A802 EQUIPMENT SCHEDULE COMMUNITY CENTER

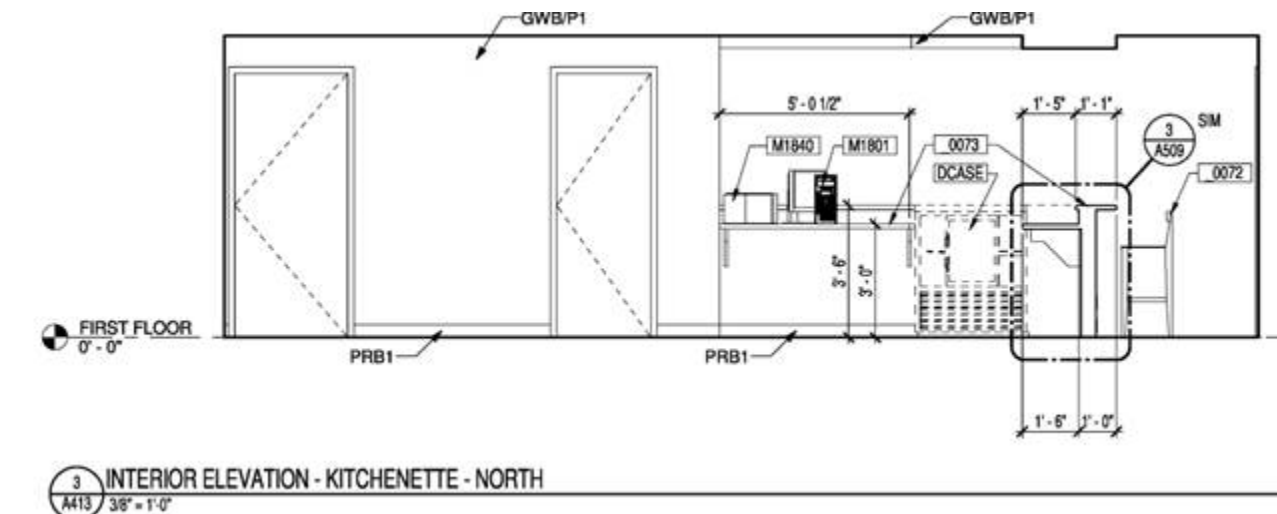
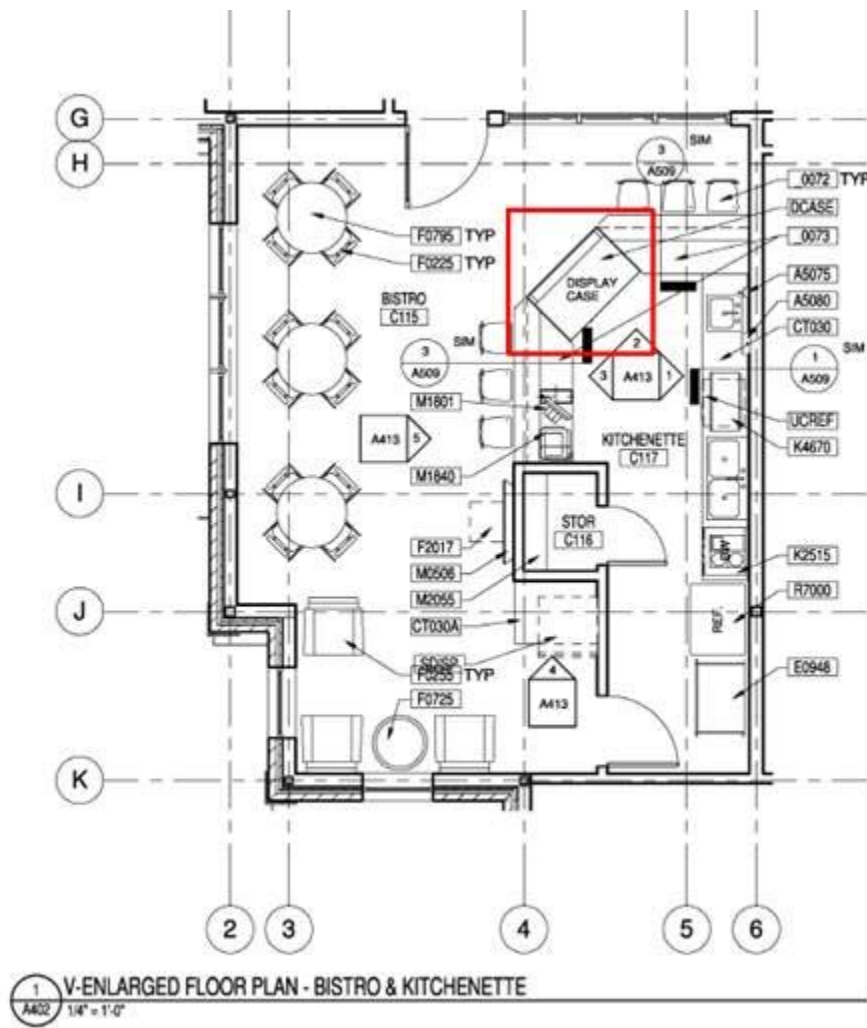
Question 1: A802 Can details or a basis of design be provided on the contractor supplied display case?

Answer: The VA Guidelines do not clarify exactly what this equipment should be. In the absence of a guide, our recommendation for a basis of design is Display Cases Triple Zone, Millrock Model No TZ36)

3
A412 3/8" = 1'-0" INTERIOR ELEVATION - PATIENT BEDROOM - T.V. WALL

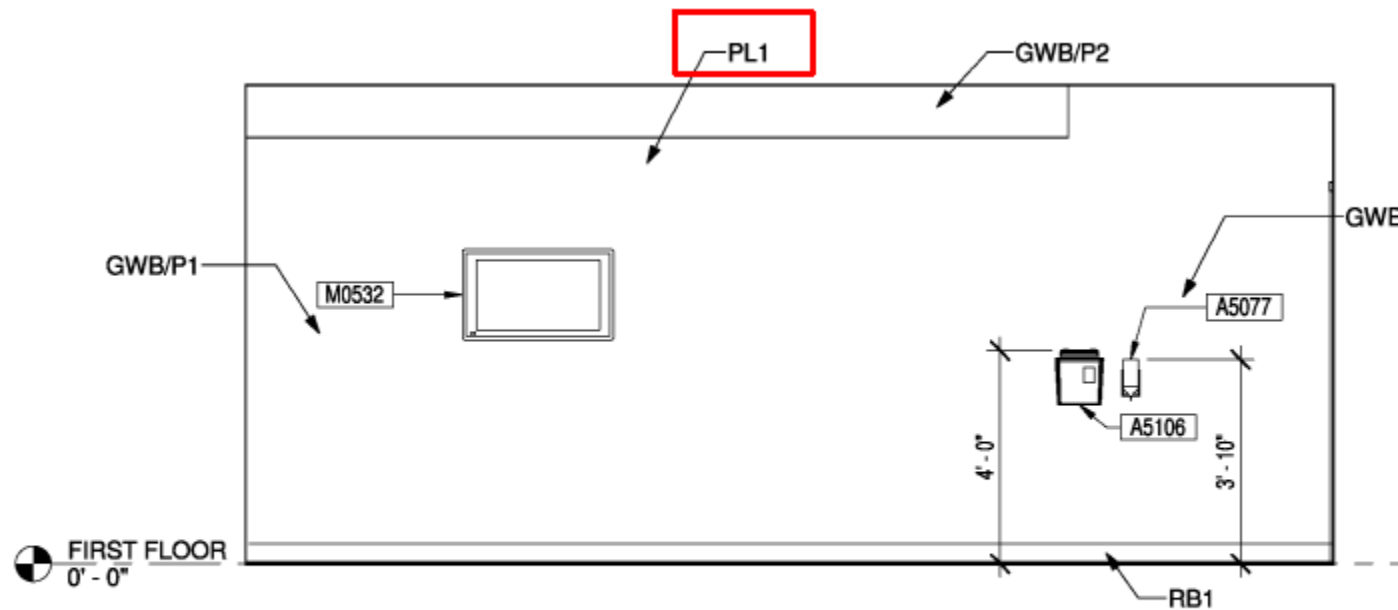
Question 5: 3/A412 Is the patient bedroom TV wall to receive P1 or PL1?

Answer: P1 (The PL1 millwork was removed from this project and the note should be deleted as well).

DRAWING A102 COMMUNITY CENTER SHELVING?

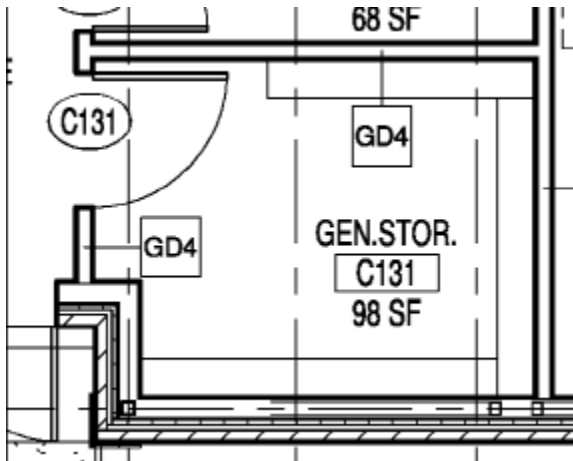
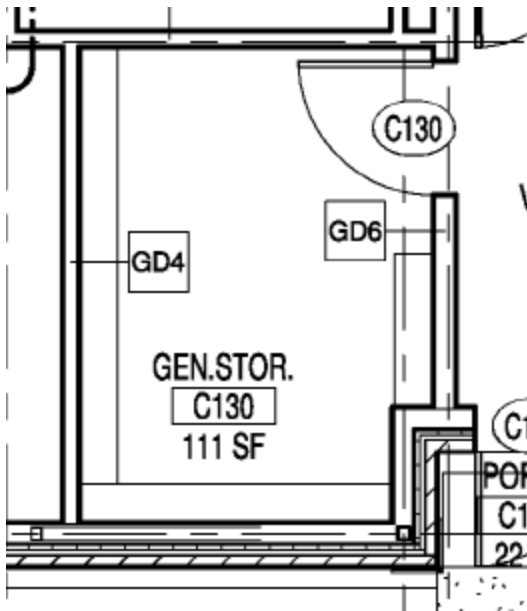
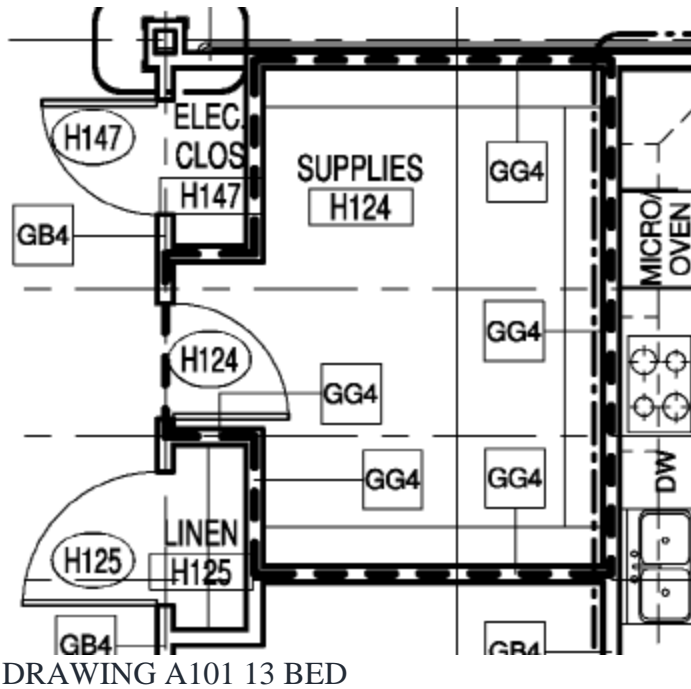
Question 6: A101 & A102 Does general storage rooms C130 & C131 or supplies room H124 receive shelving? If so please provide details.

Answer: Same answer as question 2.

A101 13 BED LINEN CLOSETS

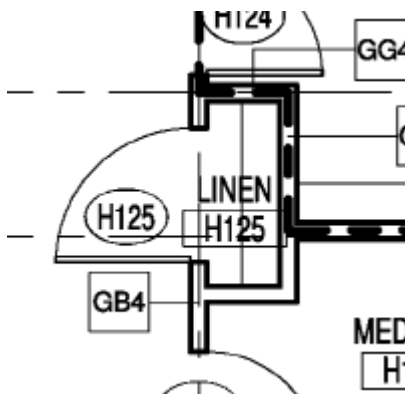
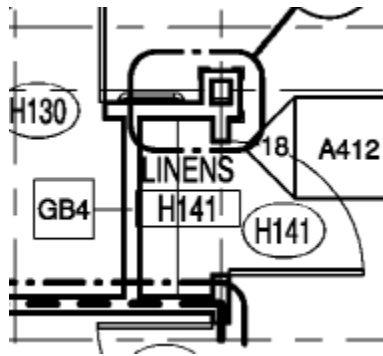
Question 7: A101 Does linen closets H125 & H141 receive shelving? If so please provide details.

Answer: Same answer as question 2.

4 V-ENLARGED FLOOR PLAN - ADMIN DESK
A401 $3/8" = 1'-0"$

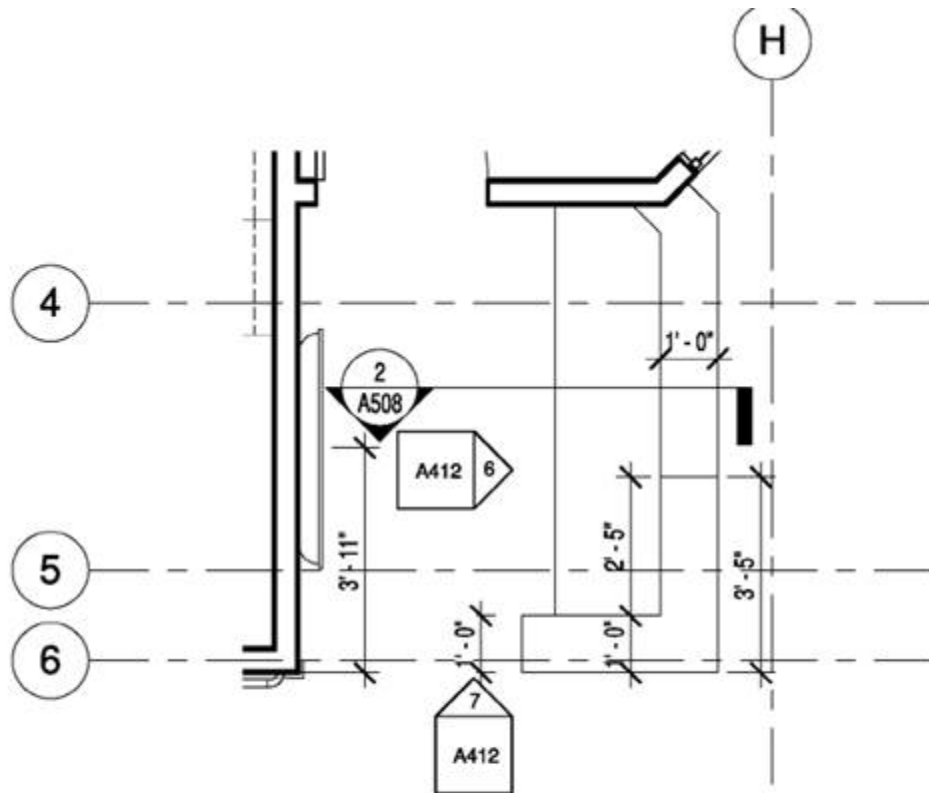
Question8: A401, A412 & A508 Does the reception desk receive a stained front or plastic laminate front? If stained, please provide wood species.

Answer: Provide white birch wood species stained WS2 as designated.

DRAWING A411 13 BED FIREPLACE

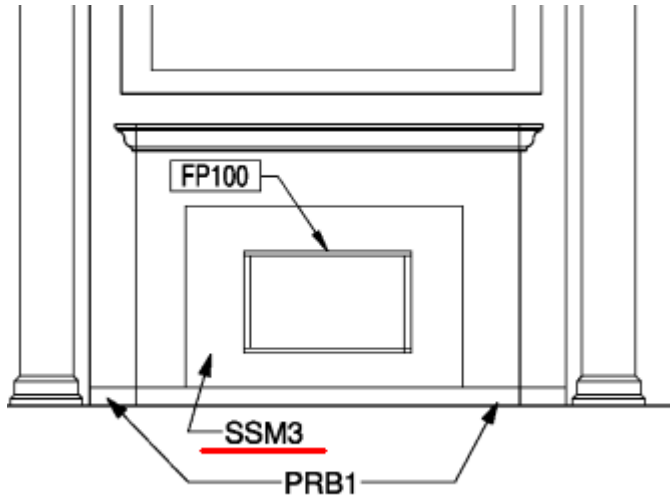
Question 9: A411 Can a finish schedule for SSM3 be provided for the fireplace surrounds?

Answer: **SSM3 shall be Solid Surface Material - Manufacturer: COMPAC – Color: VANILLE**

DRAWING A411 13 BED APPEARS TO BE RAISED PANEL WITH STAIN

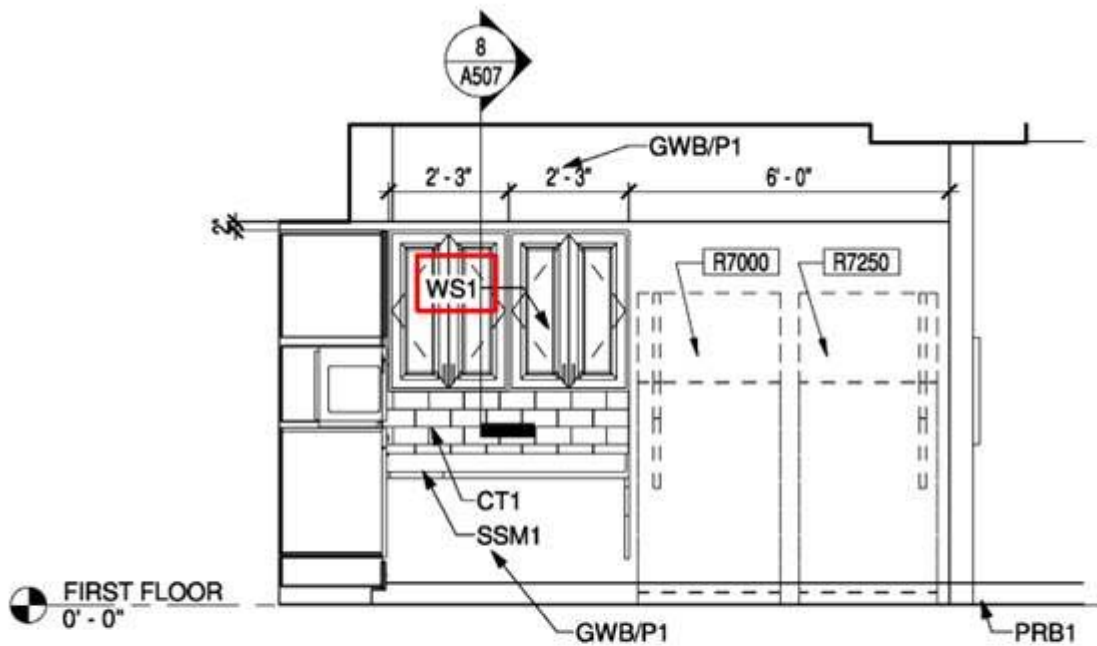
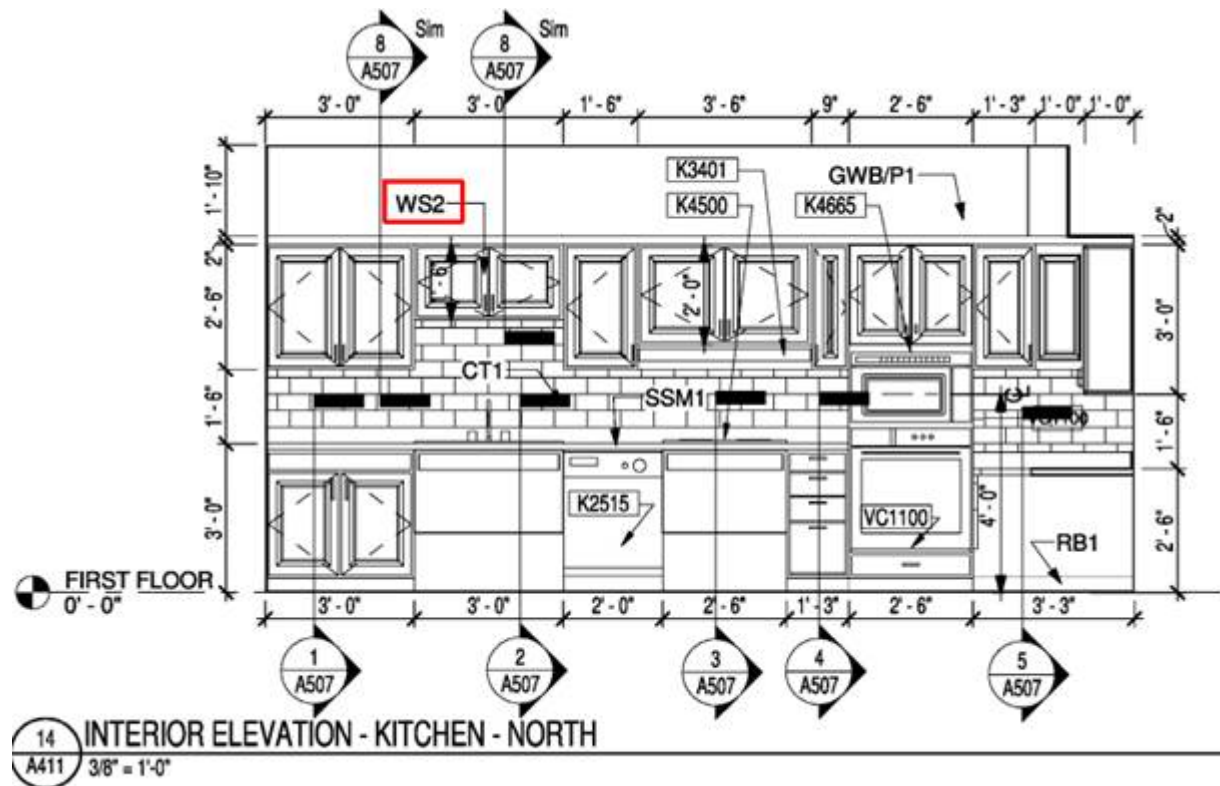
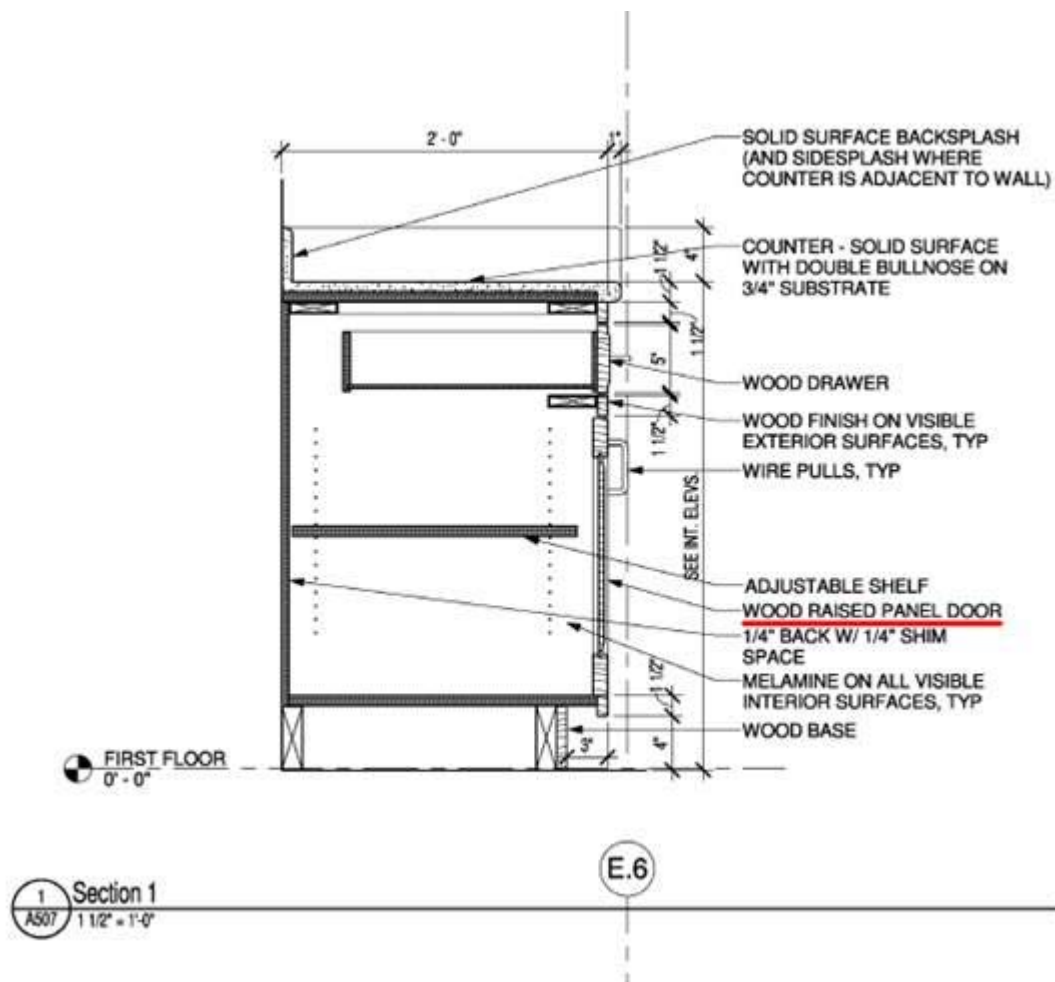
Question 10: A411 & A507 Dose the kitchen cabinets receive a plastic laminate front or wood raised panels? If wood, please provide wood species.

Answer: Provide white birch wood species stained WS1 for all base and upper kitchen cabinets.

8 UPPER CABINET SECTION
A507 1 1/2" = 1'-0"

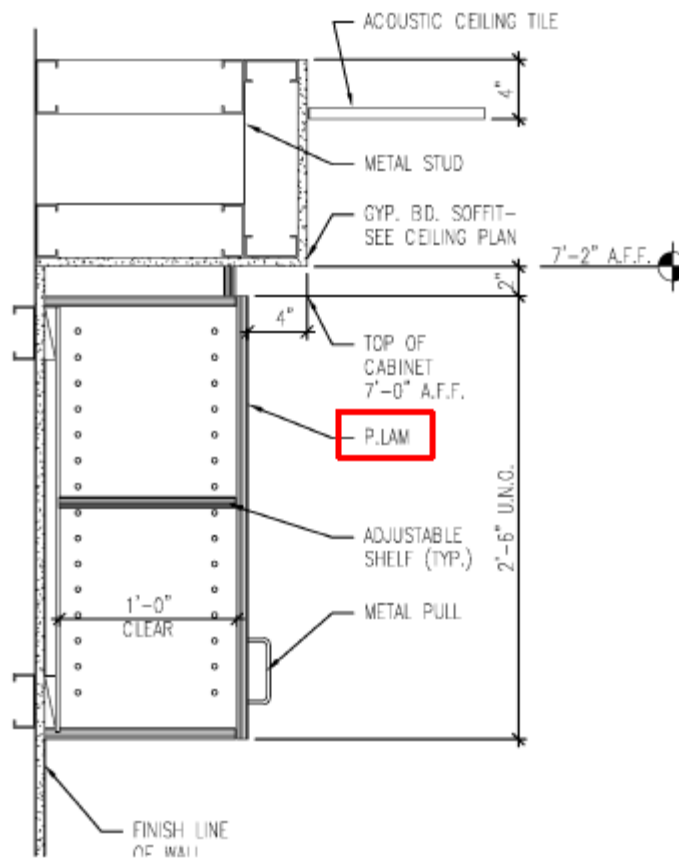
DRAWING A507 SHOWS PLASTIC LAMINATE FRONTS/DOORS

4 Section 4
A507 1 1/2" = 1'-0"

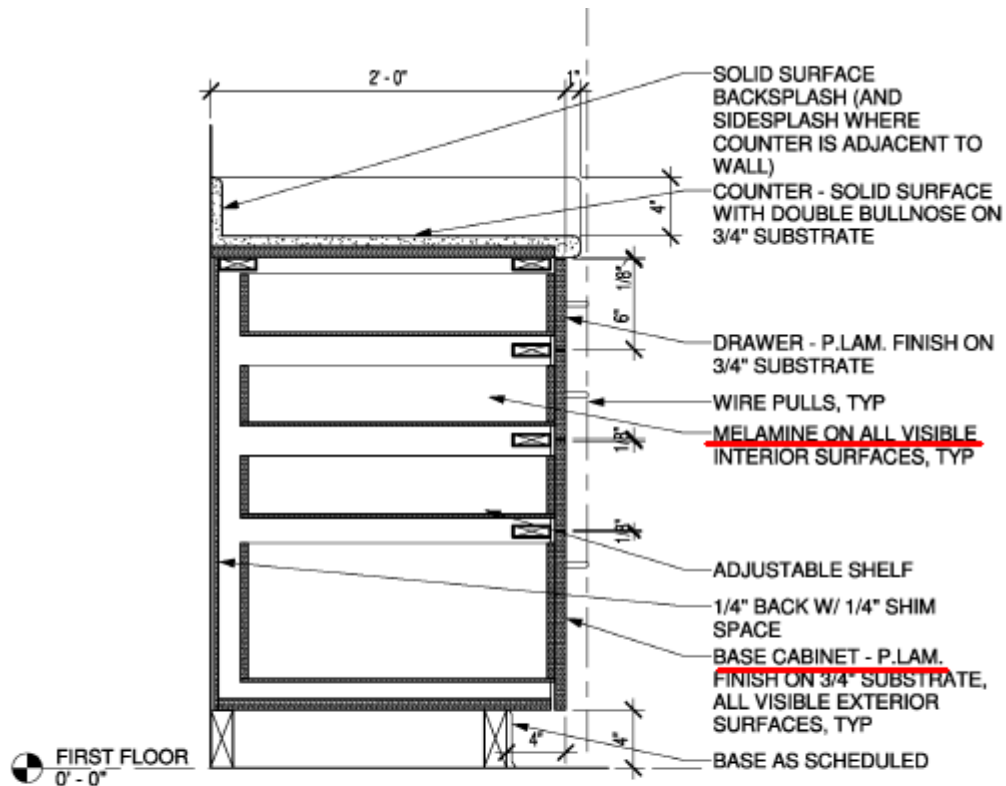
DRAWING A507 SHOWS PLASTIC LAMINATE FRONTS

15
A411
INTERIOR ELEVATION - LIVING ROOM - SOUTH
3/8" = 1'-0"

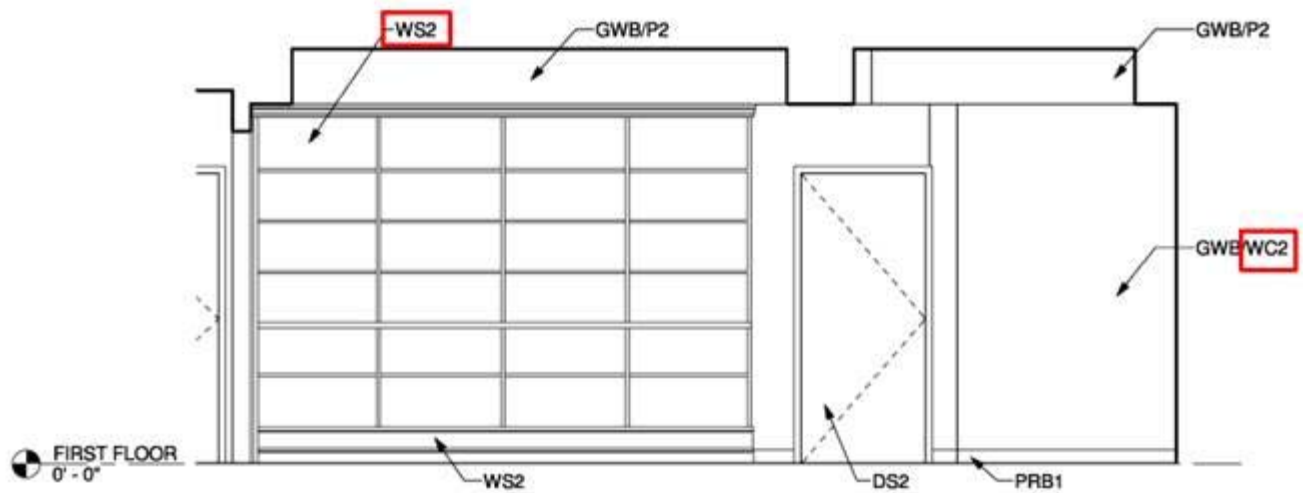
Question 11: 15/A411 Is the casework shelving to be stained? If so please provide wood species.

Answer: Provide white birch wood species stained WS2 as designated. Provide WC2 as indicated in interior elevation 15/A411.
